1636 Argonne Place NW

BZA 18980 - Prepared by Appellants – 7/7/15

BZA 18980: Summary of Errors
Prepared by Appellants – July 7, 2015

The Rear Grade

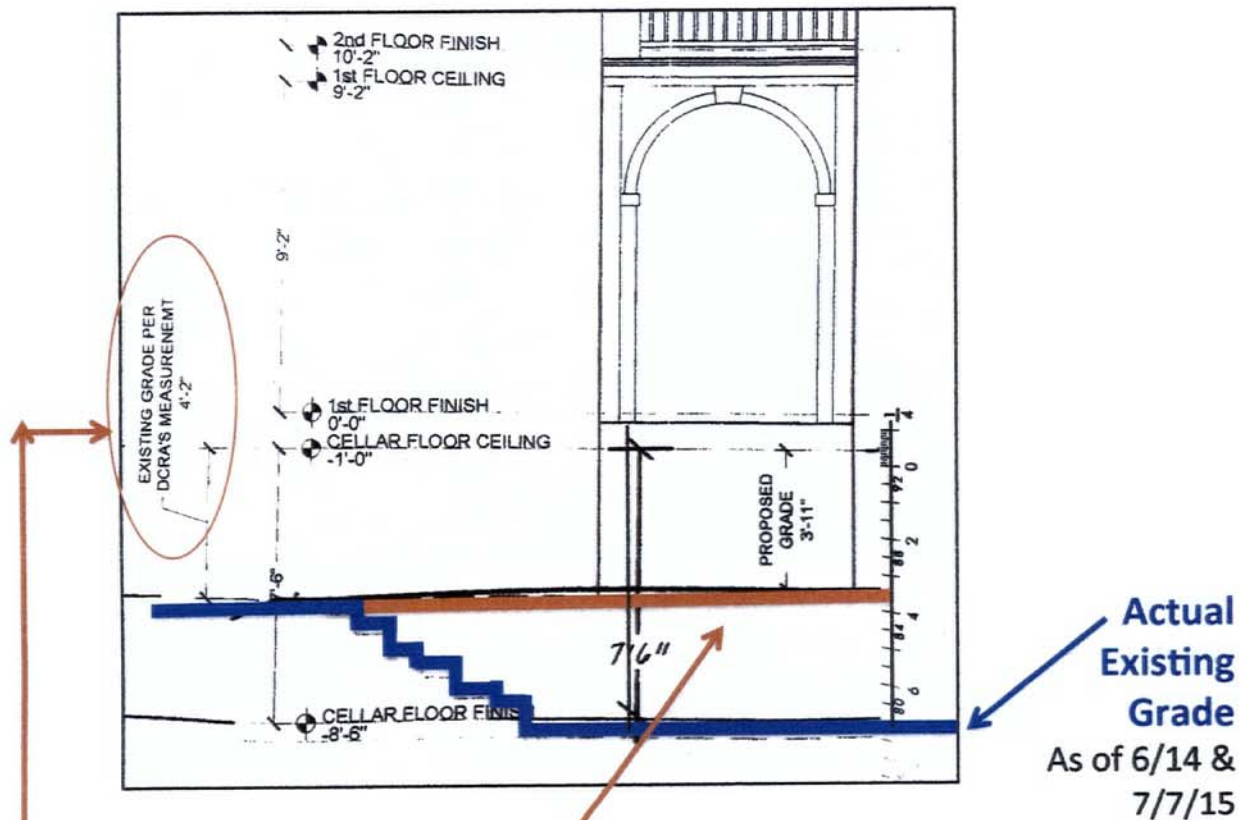
*Red Line = Misrepresentation of Existing Grade
in Order to Change FAR Calculation of Lower Level
from Basement Grade (>4') to Cellar Grade (<4')*

This Grade Does Not Exist and Cannot Exist (It Is Part of Interior Living Space) But is Used to Misrepresent Grade/FAR

- Depicted in 6/14, 12/14, 6/15 Drawings
- 12/14 Drawing Notation: "EXISTING GRADE PER DCRA'S MEASUREMENT 4'2"
- This Notation is Omitted in 6/15 Drawing
- Shows Proposed Grade Within Interior Space, Which is Impossible to Build

ZONING QUESTIONS

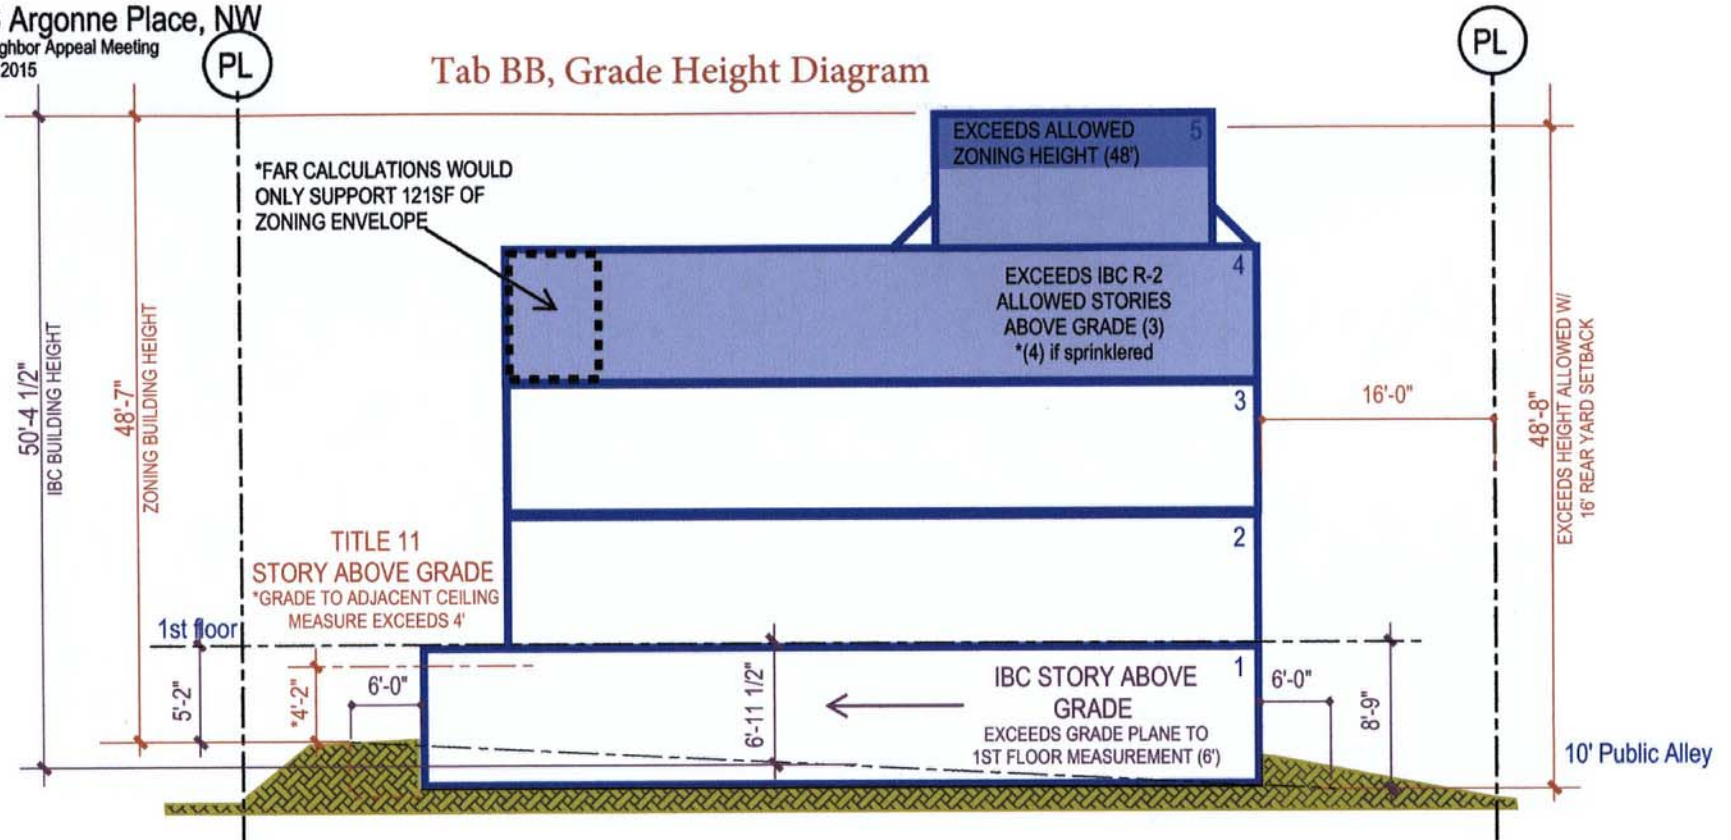
1. Grade measurement first presented (4'-2" to Basement ceiling) to DCRA was verified, which ties the project to a Basement interpretation. Zoning definition of a story above grade is tied to building height calculation.
2. IBC grade plane calculation on the August 2014 drawings is not supported by the actual grade measurements. Actual grade plane calculation ensures a "story above grade" which limits the project to the first 3 levels
3. Built height allowed for a 16' rear yard setback height is 48'; only by modifying/ raising the grade is the height compliant.

NOT A MEZZANINE

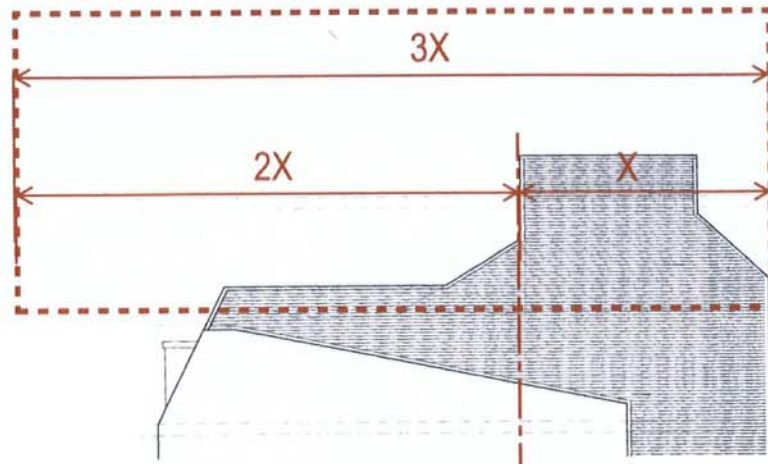
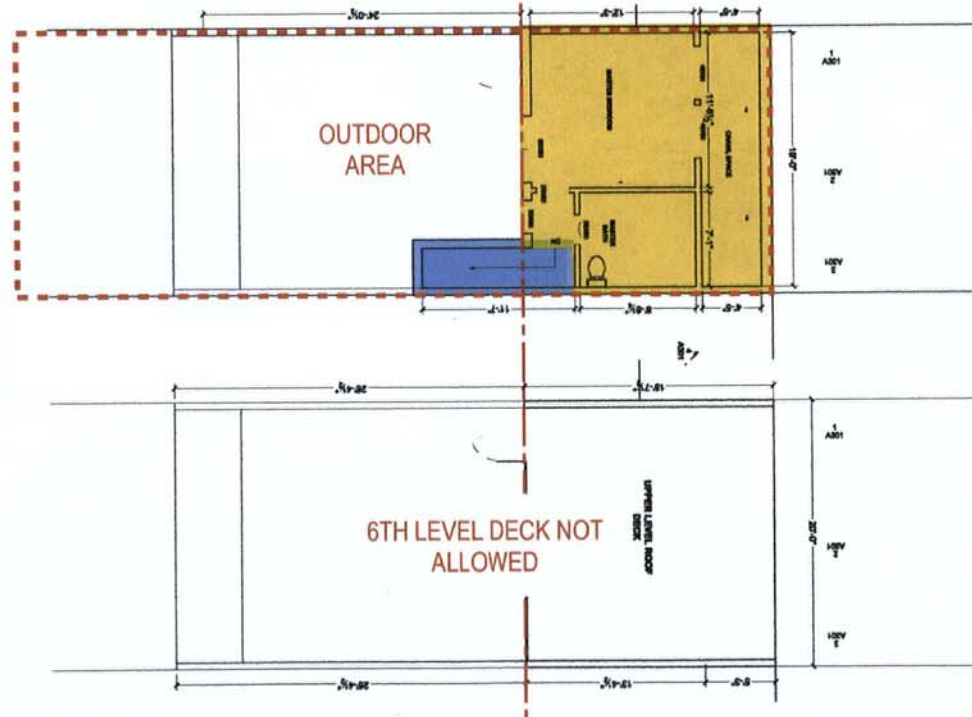
The Permit plans made available for review indicate the top story as a mezzanine. Neither the IBC nor Title 11 support this designation. Review of the attached graphic coupled with the definition from *Title 11 Section 199.1 Definitions* are presented to show the discrepancy.

5TH LEVEL FLOOR SPACE (DISALLOWED AS PART OF R-2 USE) UNLESS CONSIDERED WITHIN A STORY SHOULD BE MAX. 1/3 TOTAL

PORTION OF THE FLOOR IMMEDIATELY BELOW SHOULD BE NO LESS THAN 2/3 TOTAL TO QUALIFY AS MEZZANINE
